CITY PLANNING COMMISSION

- APPLICATION:
- A. Ratify Negative Declaration
 - B. Rezone 3 vacant corner lots totaling 0.4 acres from Single Family (R-1) to Townhouse (R-1A) zone (Zoning Ord., Sec. 7)
 - C. Tentative Parcel Map to subdivide 3 existing corner lots into six halfplex lots (Sub. Ord., Chapter 40)
 - D. Special Permit to develop 6 halfplexes (Zoning Ord., Sec.-7)

PROPOSAL: The applicant is requesting the necessary entitlements to develop six halfplex units on three corner lots in the Riverwind Subdivision.

APPLC. NO. P84-189

site plan
 SCALE: 1/8" = 1'-0"
 LOT 9 RIVERSIDE MANA UNIT No. 1

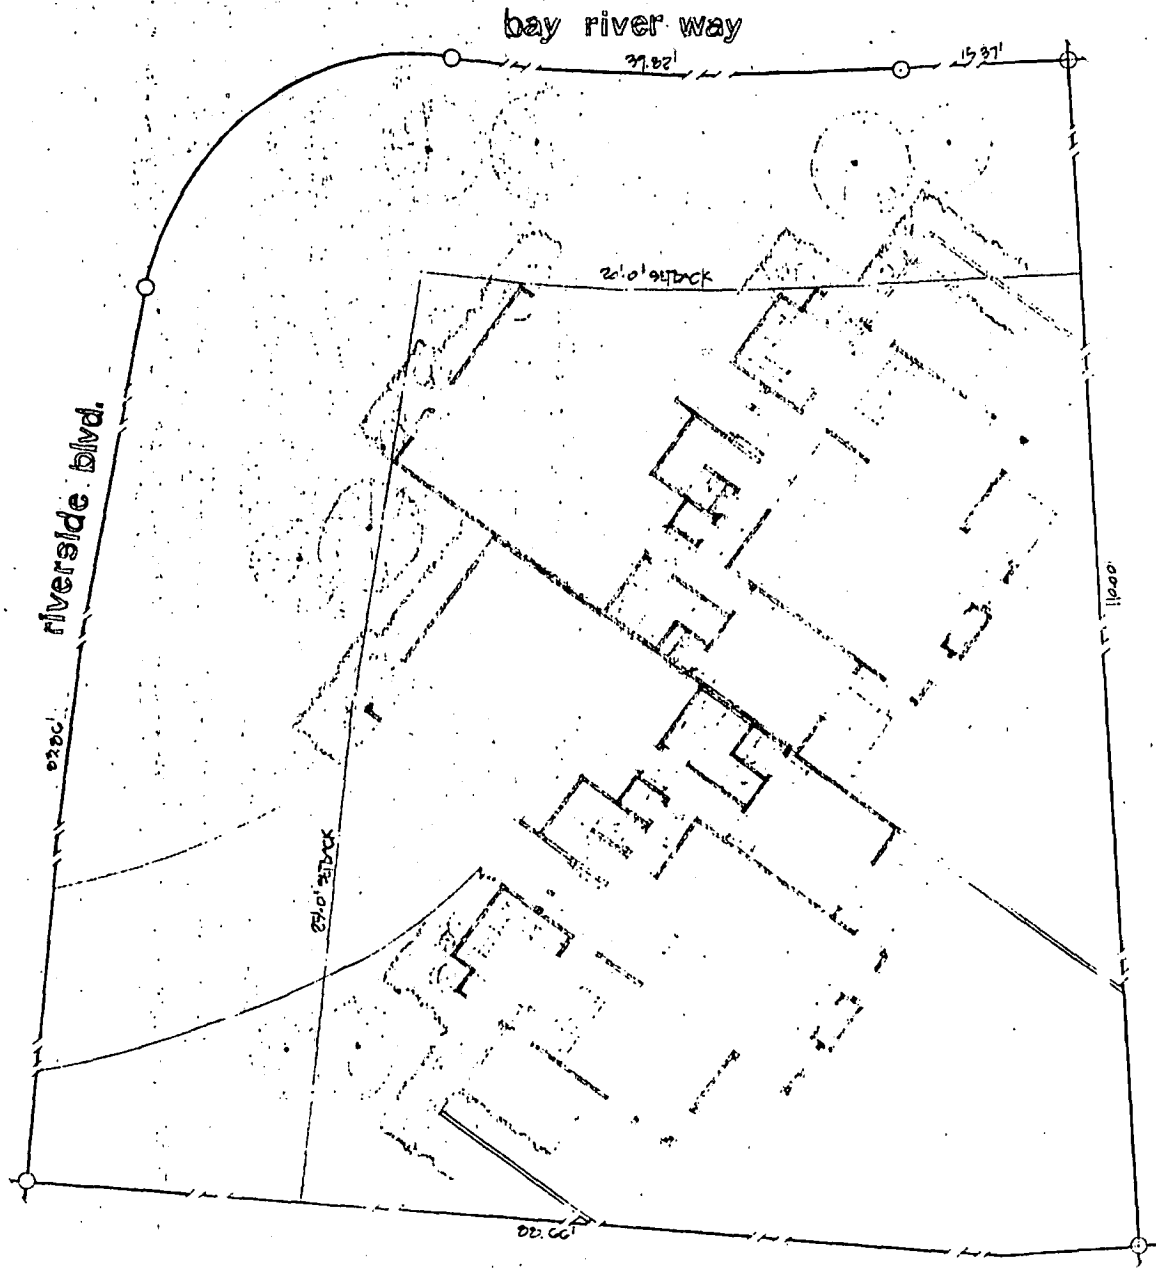
2. The applicant proposes to locate each structure at a diagonal angle on the lot. Under the R-1A zone, which allows flexibility regarding building setbacks, the front yard setback is proposed at 20 feet rather than the standard 25 foot setback under the R-1 zone. The front yard setback for all existing homes adjacent to the three proposed structures is 25 feet. Staff, however, does not necessarily oppose the proposed 20-foot building setback, based upon the design and diagonal placement of the structures on each lot. The front and side elevations of each structure contain many offset planes which tend to present an interesting facade from street view rather than the typical flat plane facade of most typical halfplexes. Due to these offsets and diagonal placement of the structure on the lot, only the corner of the kitchen and corner of the garage project into the standard 25-foot front yard setback area. The remainder of the front building plane is recessed behind the proposed 20-foot front yard setback.

In addition, the front of the garage is located at an angle to each street which reduces the visual impact of a large garage door from the street perspective. From the street corner, one would be viewing the sides of the two garages rather than the garage doors.

The only modifications requested by staff relative to the site plan is that the six-foot high fence proposed to extend beyond the 20-foot front yard setback be held back at the 20-foot setback line, and that all curved driveways turn 90° at the sidewalk and maintain a minimum 20-foot distance between the front of the garage and property line at the closest point.

- 1. The primary exterior building materials of all three structures shall consist of horizontal wood siding and wooden shake roofs.
- 2. The six-foot high patio fence proposed in the front yard setback area shall be set back 20 feet from the front property line.
- 3. The distance of all driveways between the front of the garage and front and street side property lines at the closest points shall be a minimum 20 feet. The curved driveways shall be modified to turn at a 90° angle to the sidewalk.
- 4. Revised plans indicating the above items shall be submitted to staff for review and approval prior to issuance of building permits.
